**APPLICATION FOR  
URBAN DESIGN COMMISSION  
REVIEW AND APPROVAL**

PROJECT ADDRESS: 25 W. MAIN ST., MADISON, WI 53703

# PROPOSED CHANGES TO THE REDEVELOPMENT OF ANCHOR BANK

submitted as a minor alteration to previously  
approved conditional use by the City of  
Madison and the Urban Design Commission

# I. THE BULK OF THE BUILDING'S 9<sup>TH</sup> FLOOR WILL BE CONVERTED FROM MECHANICAL SPACE TO OFFICE SPACE

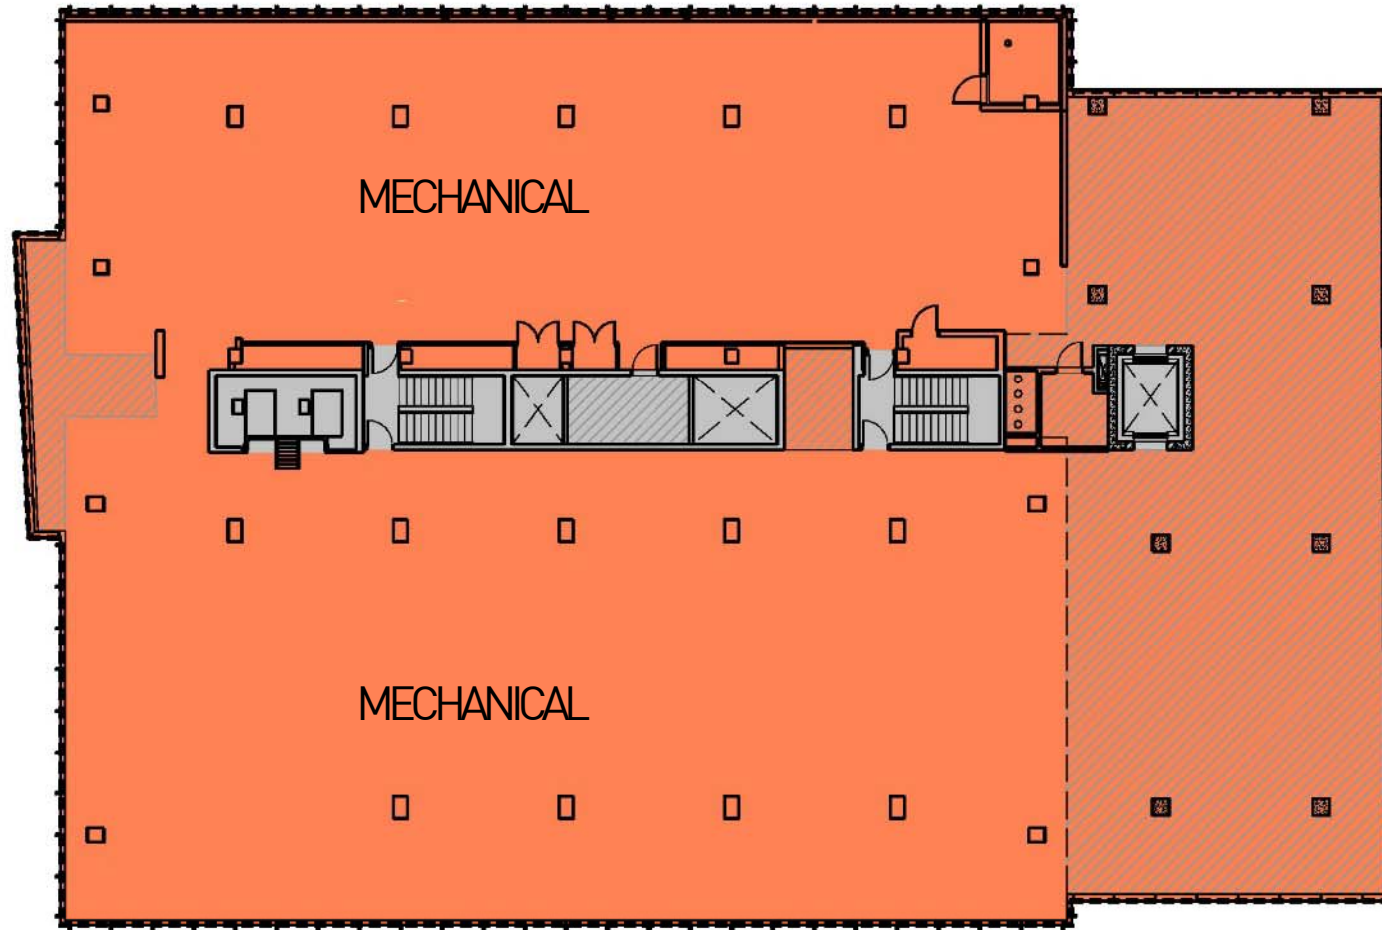
The west, north and south sides of the ninth floor of the building, which had been exclusively used as space for mechanical equipment, will be converted for use as offices. This conversion adds 15,368 rsf of office space to the project.

Installation of a new curtain wall that would have been spandrel glass over existing precast concrete panels on the ninth floor had already been proposed and approved by the City. The spandrel glass will be converted to vision glass that will be extended to the building's roof.

The projecting glass bay that defines and extends over the building entrance is proposed to be widened by 10 feet and extended to the roof. With the cut back in the existing building's floor plates, the projecting bay is critically important to knit together the east and west side of the building. This makes it necessary to extend the bay up to include the ninth floor. The projection of the floor plate has been pulled back in towards the building by 4 inches from what was previously approved.

# AREA BREAKDOWN - LEVEL 9

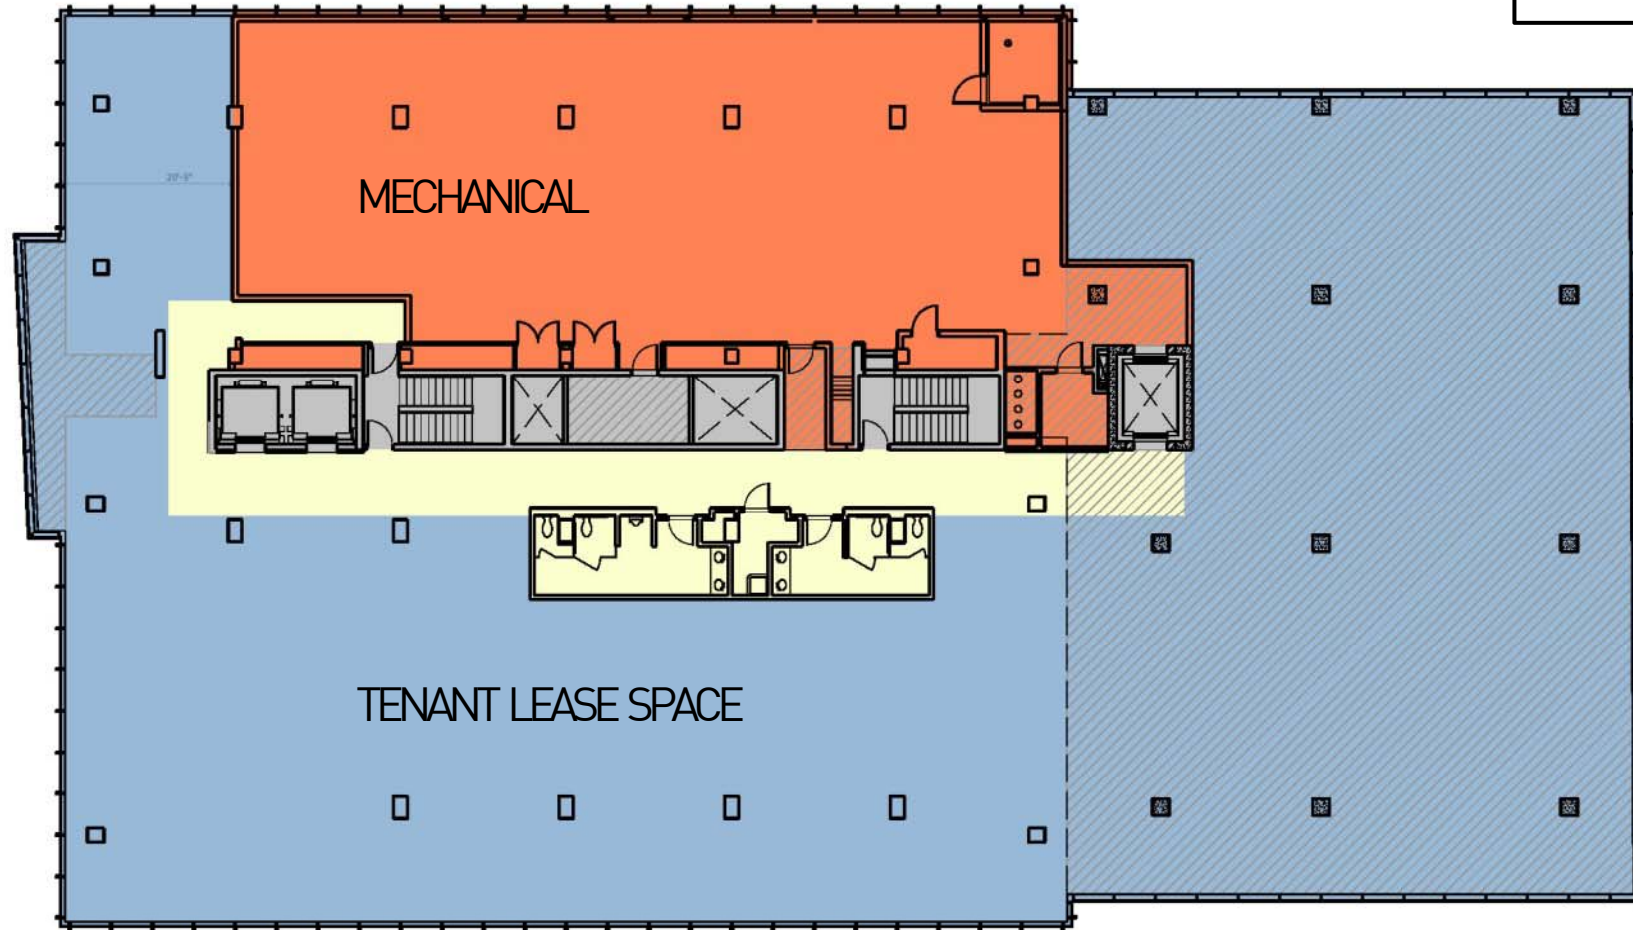
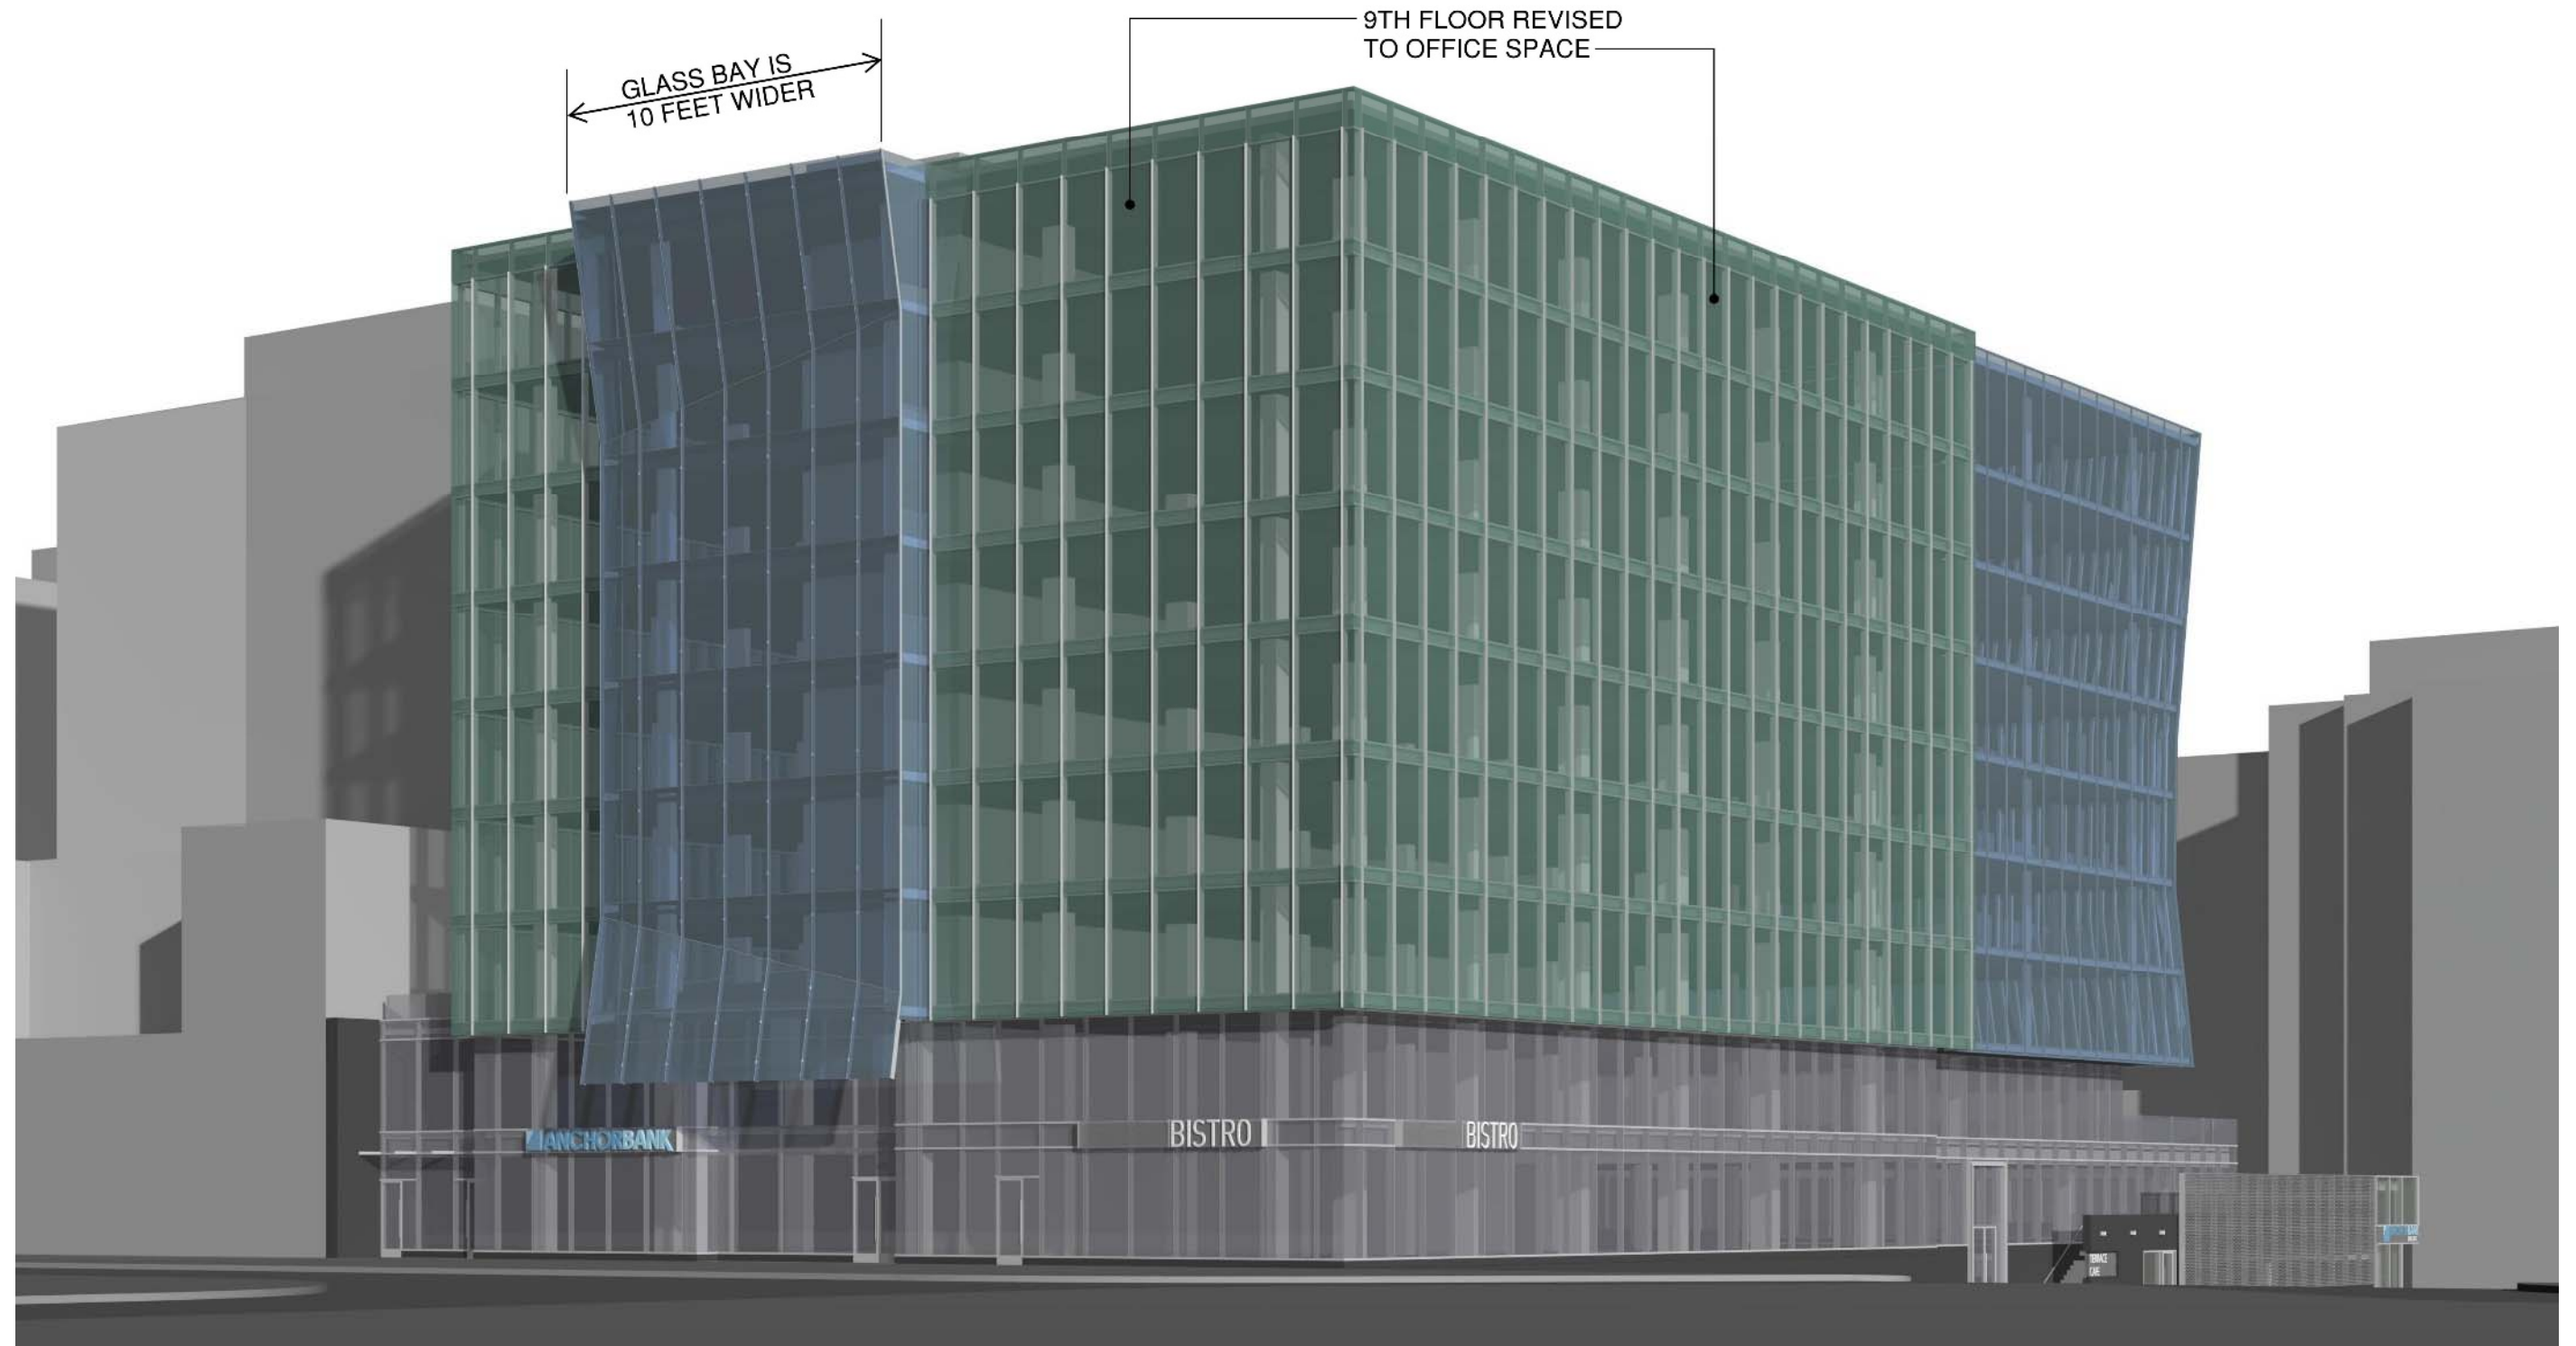
ENTIRE 9<sup>TH</sup> FLOOR WAS USED FOR MECHANICAL PURPOSES.

MECHANICAL EQUIPMENT WILL BE RELOCATED TO THE ROOF CREATING APPROX. 15,000 SF OF OFFICE LEASE SPACE.

# EXTERIOR VIEW 1 - along main st.

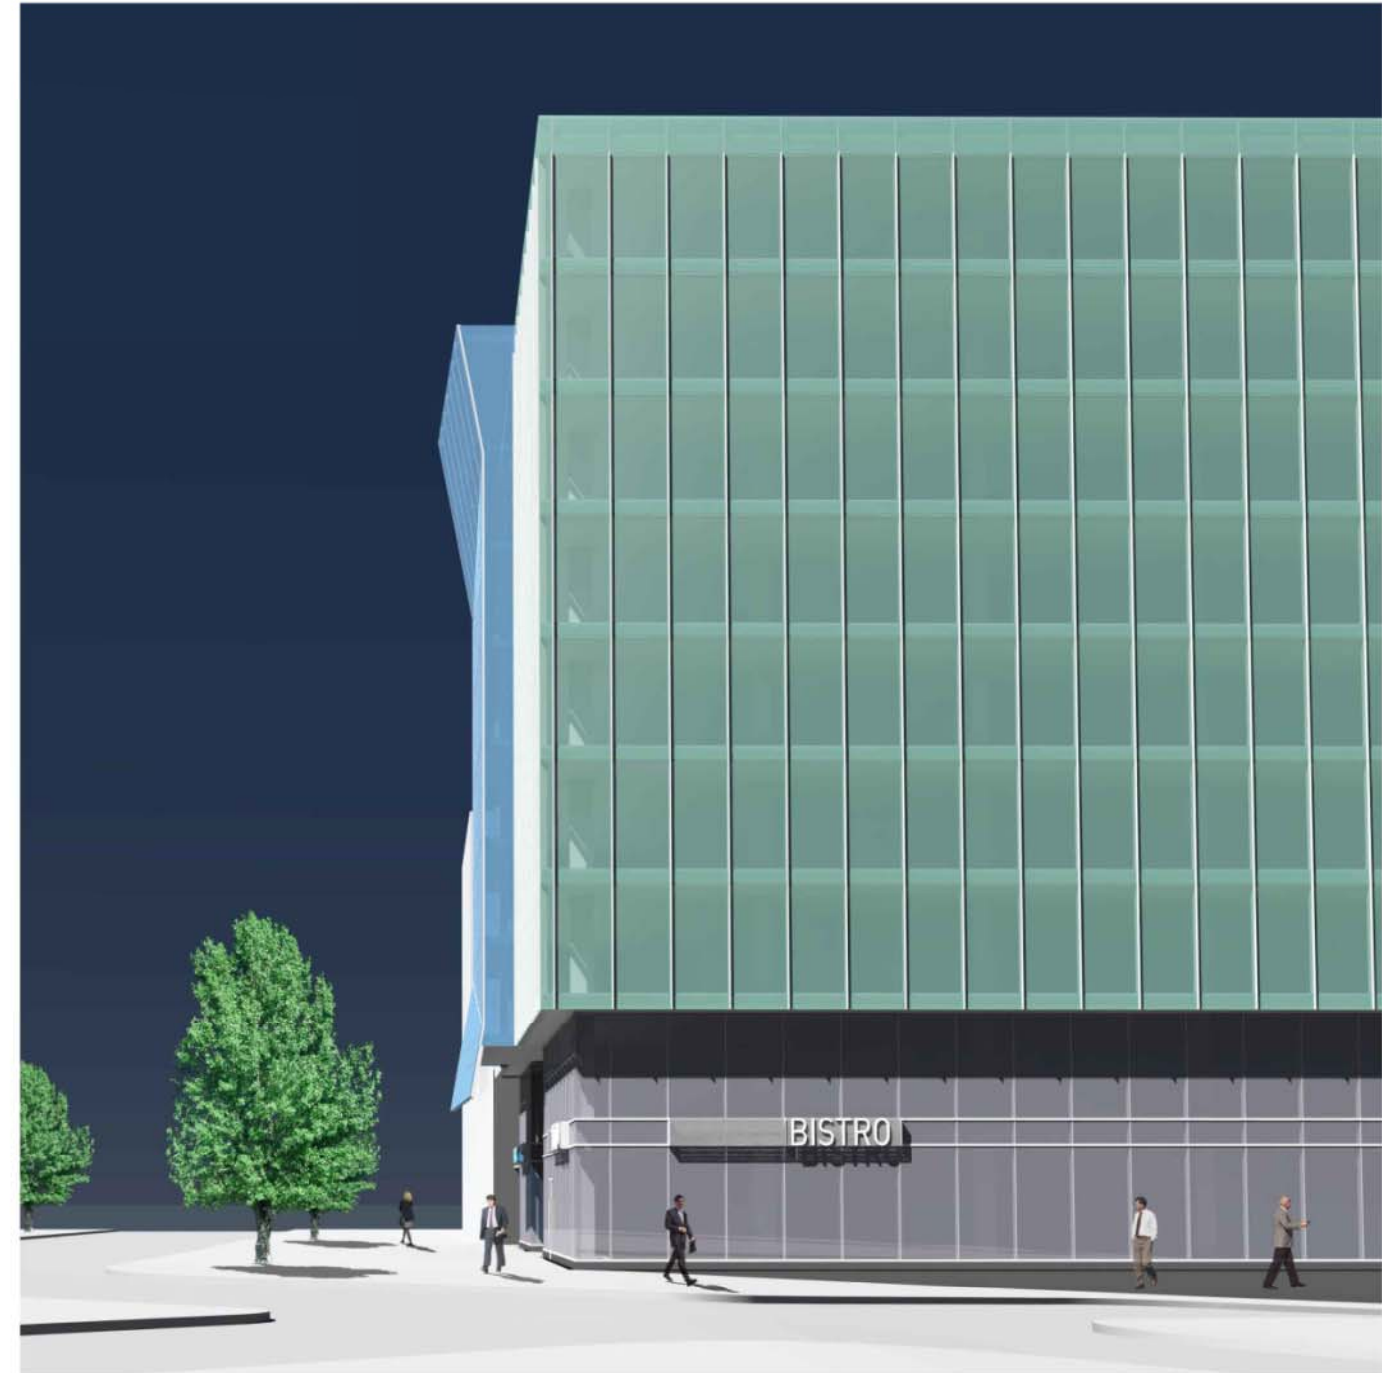
PREVIOUS DESIGN

CURRENT DESIGN
